PRELODGE MENT PANEL ADVICE EIS CONSULTATION AND ADVICE

PROPERTY: 363-373 Victoria Road and 44-48 Eltham Street,
Gladesville

PRELODGE MENT No: PRL2025/0029 - SSD-82225458

DEVELOPMENT: Demolition and construction of a 12-storey mixed use residential development, including retail premises, 186 residential dwellings, basement parking and associated landscaping and deep soil.

Figure 5: Markup of Plans showing potential ADG Non-Compliance (Base Source: CHC)

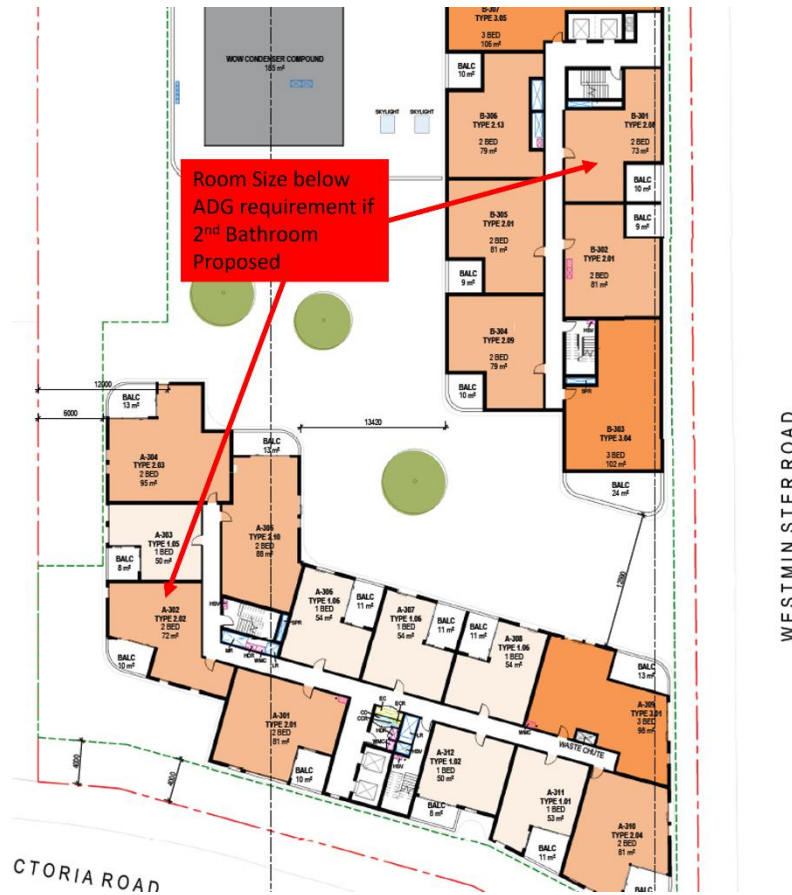
Of note is clause 148(2)(b) which requires minimum areas of apartments to be consistent with Part 4D of the Apartment Design Guide (ADG). Clause 4D of the ADG is shown in **Error! Reference source not found.** In review of the submitted plans, its shown that some apartments do not comply with the minimum internal area under the ADG.

Whilst the applicant hasn't resolved detailed internal specifics that would affect apartment sizes, it appears that there are several 2-bedroom units that are below the 75m² room requirement if a second bathroom is proposed (Figure 5).

Note: *The applicant is advised to carefully review all their apartment sizes on SSDA submission to ensure compliance with the minimum apartment area and is recommended to comply with apartment size requirements.*

Figure 7: Mark up of area where Building Height would encroach (Base Source: CHC)

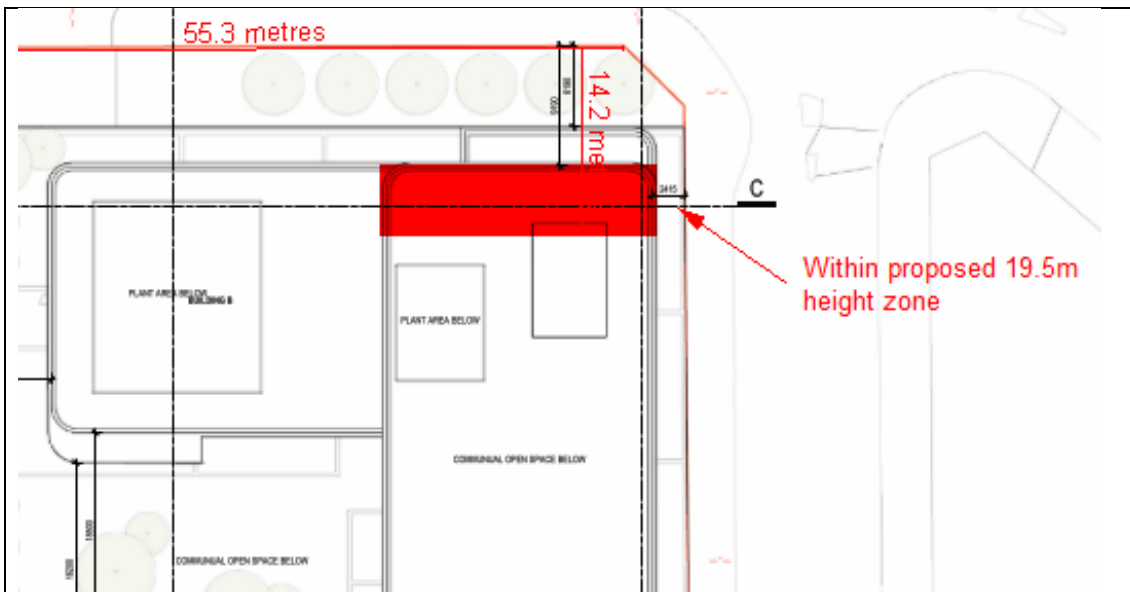
Based on the plan it appears that the application as proposed would necessitate a clause 4.6 for building height as a portion of the 7-story building would extend into the proposed 19.5m building height area. This is demonstrated in Figure 7 & Figure 8. It is recommended that:

- The applicant reconsider their height strategy over the site to avoid a technical non-compliance. Or;
- Provide a Clause 4.6 for Building height if still proposed.

Figure 10: Extract showing school entry opposite proposed loading dock (Source:Google Maps)

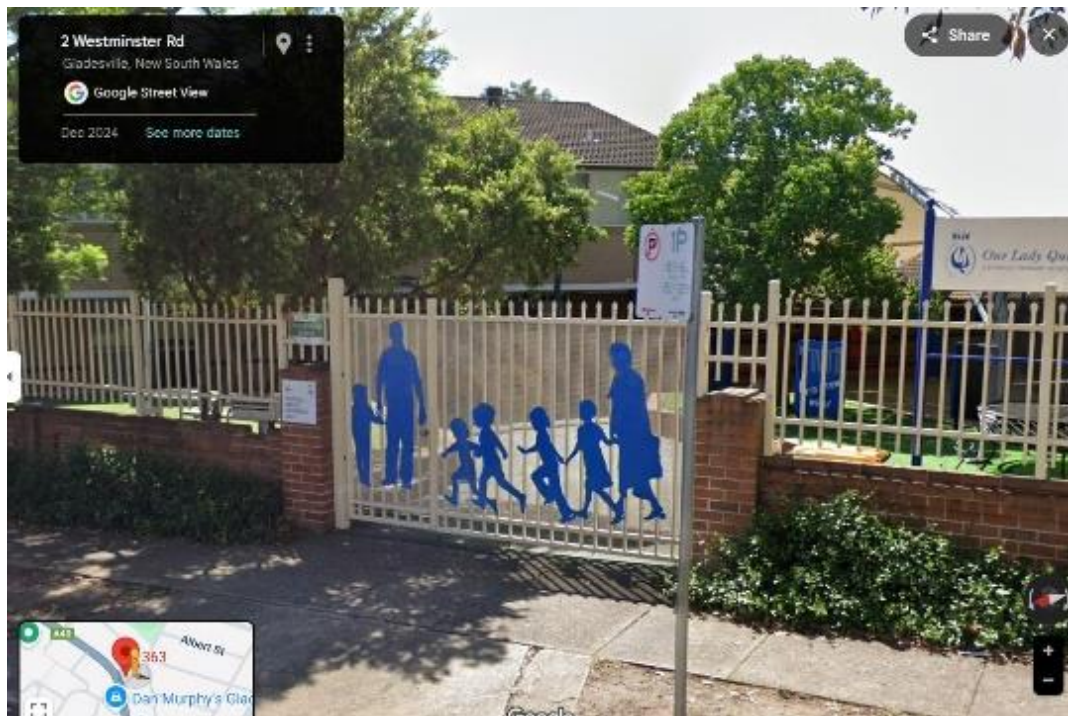
The school gate along Westminster Road is the primary access for people walking or riding to school. The vehicular access and kiss and drop are along Oxford Street. A key element of encouraging people walking and riding to school is providing a safe environment to do so. This school zone should minimise vehicular access and movement. In particular, movement of large loading vehicles that have difficulty seeing a primary school child.

The proposal can encourage a more intimate and vibrant street with raised pedestrian crossing to access the school, a small retail frontage and café. Local retail may be better located in the

Figure 11: Extract showing Council networks (Source: Ryde Maps)

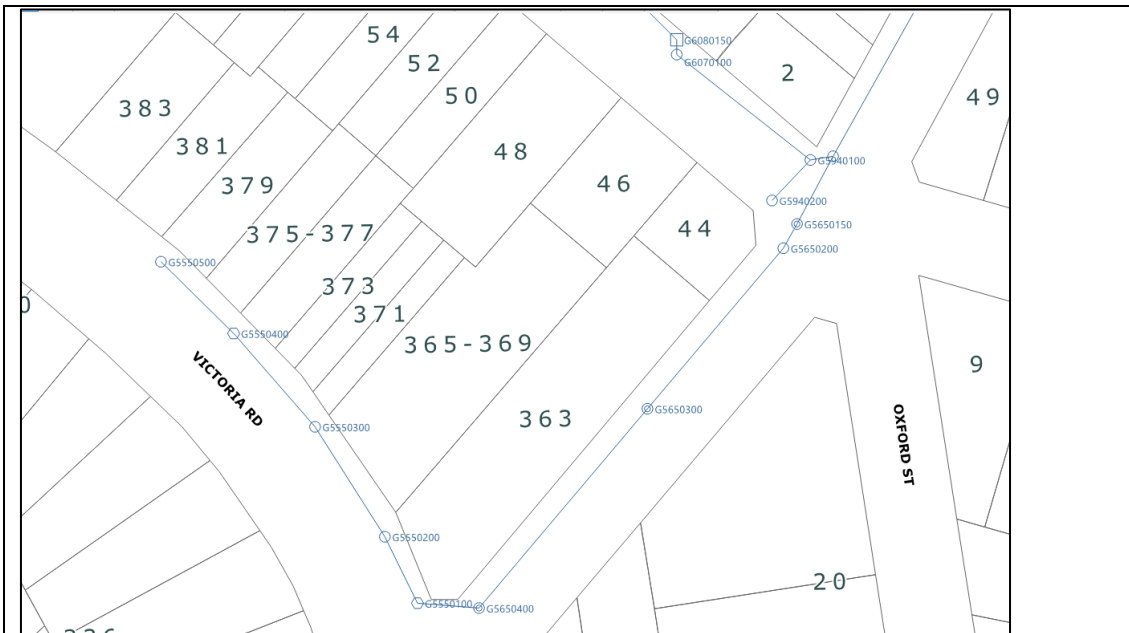
- If public domain works are undertaken to widen Westminster Road, the existing stormwater drainage infrastructure including kerb inlet pits will need to be relocated and modified to suit the new road alignment. All pits are to be positioned within the new kerb line to ensure effective surface drainage. All drainage works must be designed and constructed in accordance with Council's standards and must maintain the ongoing functionality of the stormwater system.

- Provide a drainage network capacity assessment for the proposed connection(s) to Council's stormwater system. The assessment must confirm that the receiving network has adequate capacity to accommodate the development's discharge without causing surcharge or adverse downstream impacts.

- A CCTV investigation report of the downstream drainage system is required where a new connection is proposed to an existing Council asset. The report must verify the structural condition and capacity of the receiving system to ensure it is suitable for accepting the proposed discharge.
